DS-K1T341A Series MinMoe Terminal

Release Notes (2023-06-12)

Device Model: DS-K1T341AM DS-K1T341AMF Naming Rule: M for M1 card, F for fingerprint	Firmware Version	ARM: ACS_641_AI3_EN_ STD _V3.2.30_build230330 ACS_641_AI3_EN_ NEU _V3.2.30_build230330
	Software Version	HikCentral AC: https://www.hikvision.com/en/support/download/software/hikcentral-access-control-v2-0-1/

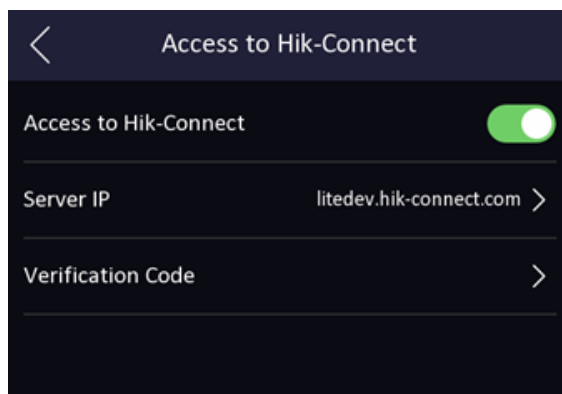
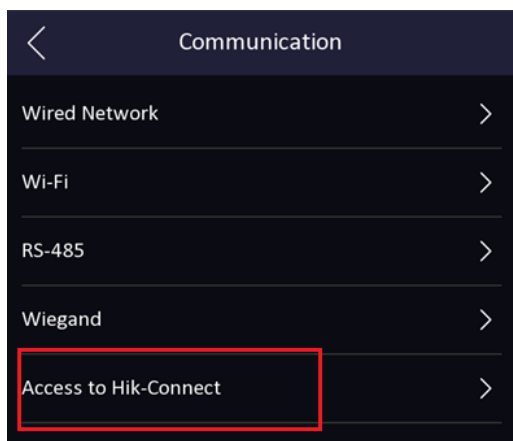
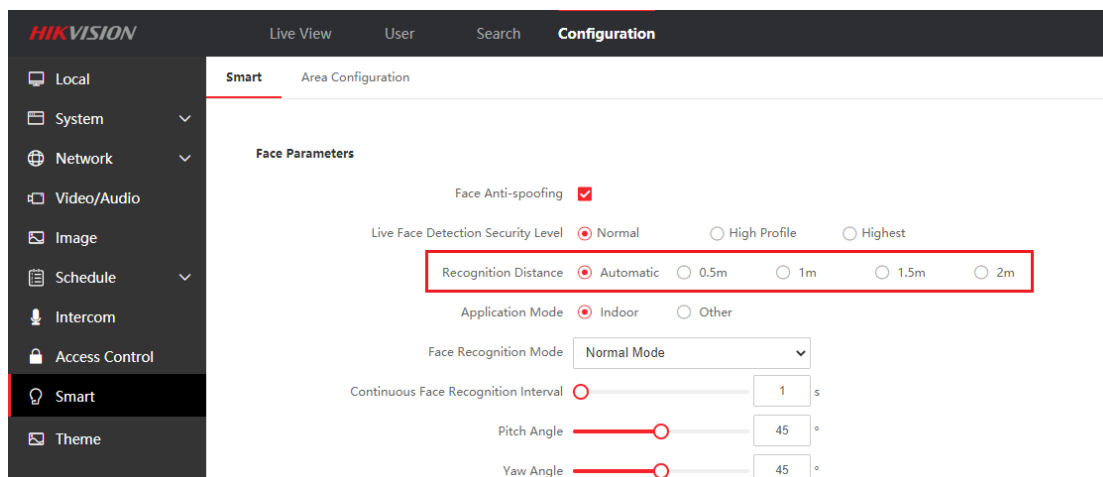
1. Add Hik-Connect menu in device UI Menu → Comm. The function is disabled in default.
